CITY OF ALBANY
Public Works Department

ADDENDUM #1

ST-22-01, Queen Avenue Rehabilitation: City Limits to Pacific Blvd.

DATE: JANUARY 24, 2023

PUBLIC WORKS DEPARTMENT
ENGINEERING SERVICES

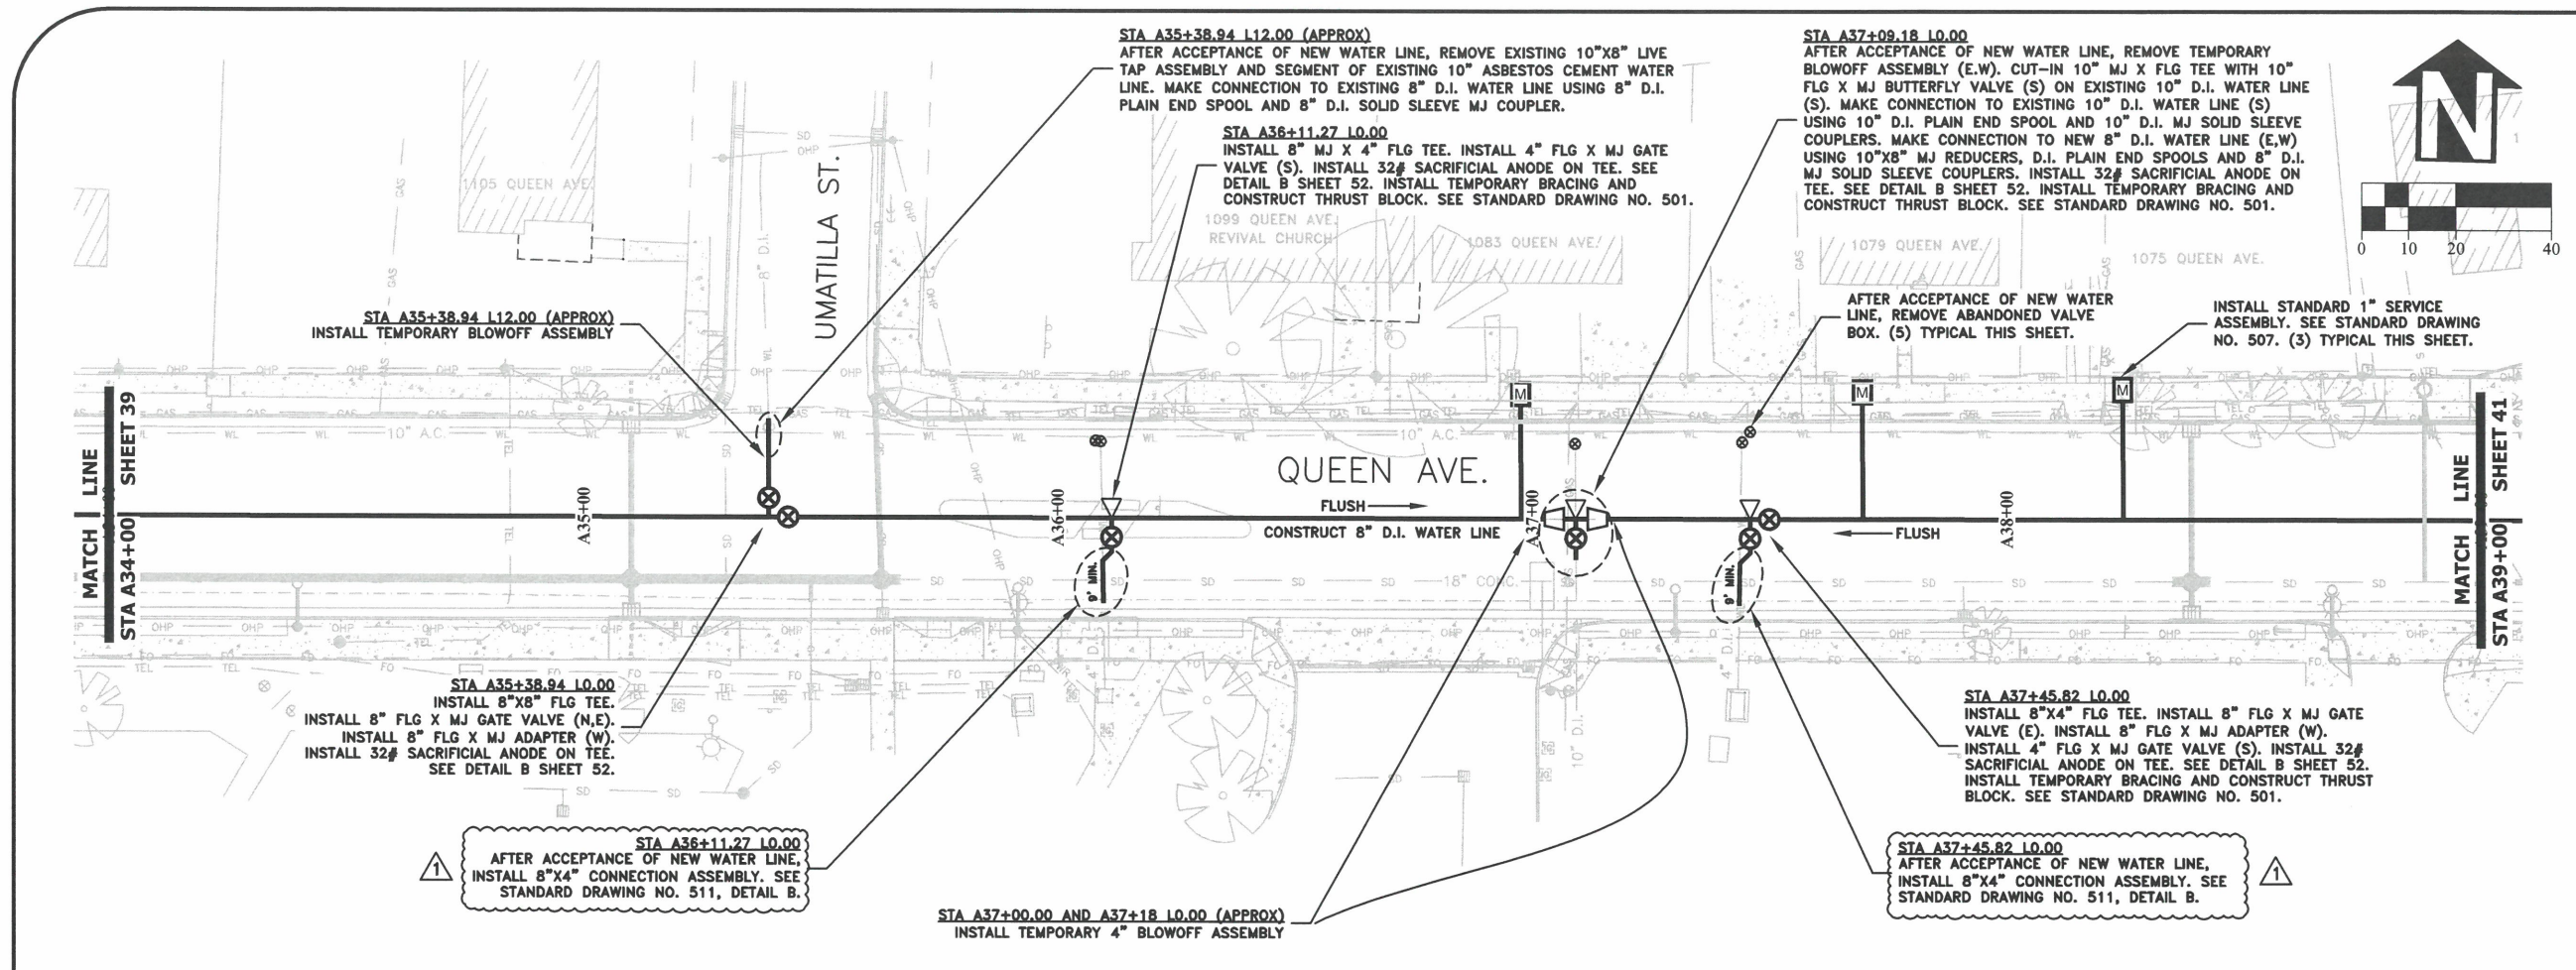
- Sheet No. 8: Updates pipe diameters for catch basin runs
- Sheet No. 9: Updates pipe between SDMH-26 and SDCB-35 is 10-inch ductile iron
- Sheet No. 40: Changes the two 4"x4" Connection Assemblies to be 8"x4" Connection Assemblies

SHEET NO. 44 OF 107
PROJECT NO: ST-22-01
FILE: BASE.DWG

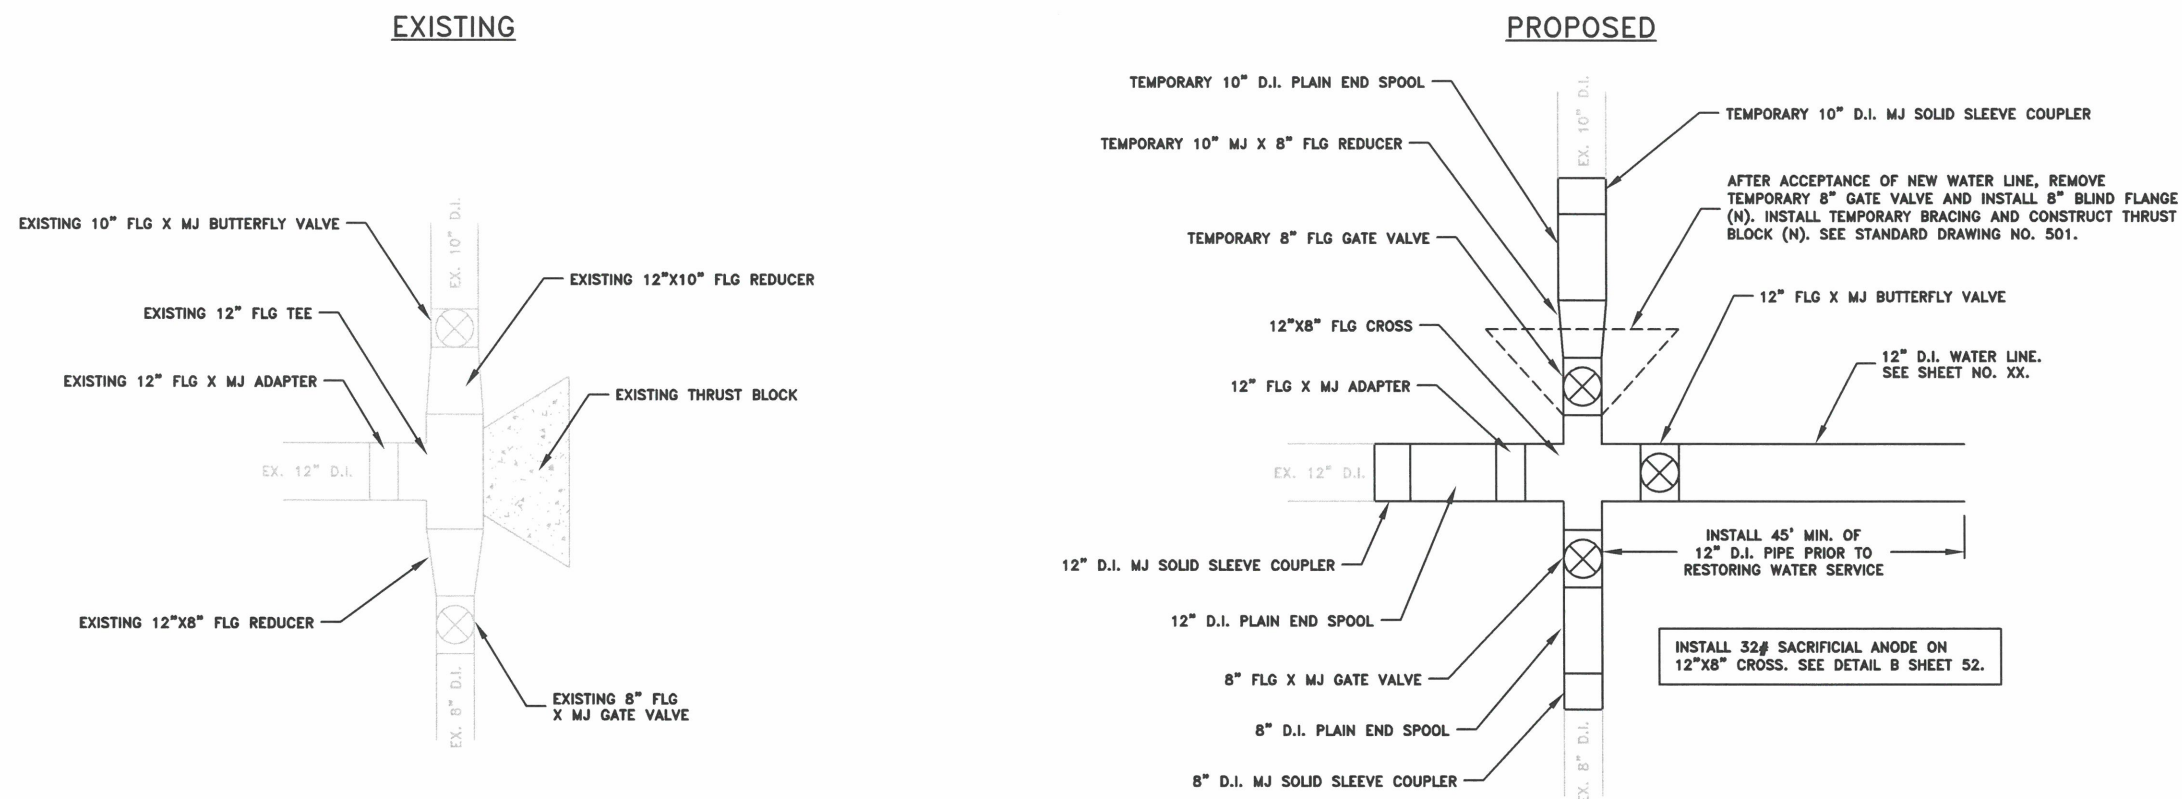
- Sheet No. 44: Added information regarding existing concrete panels on Pacific Boulevard and associated notes
- Sheet No. 53: On Detail E, changed 16-inch gate valve to 16-inch butterfly valve
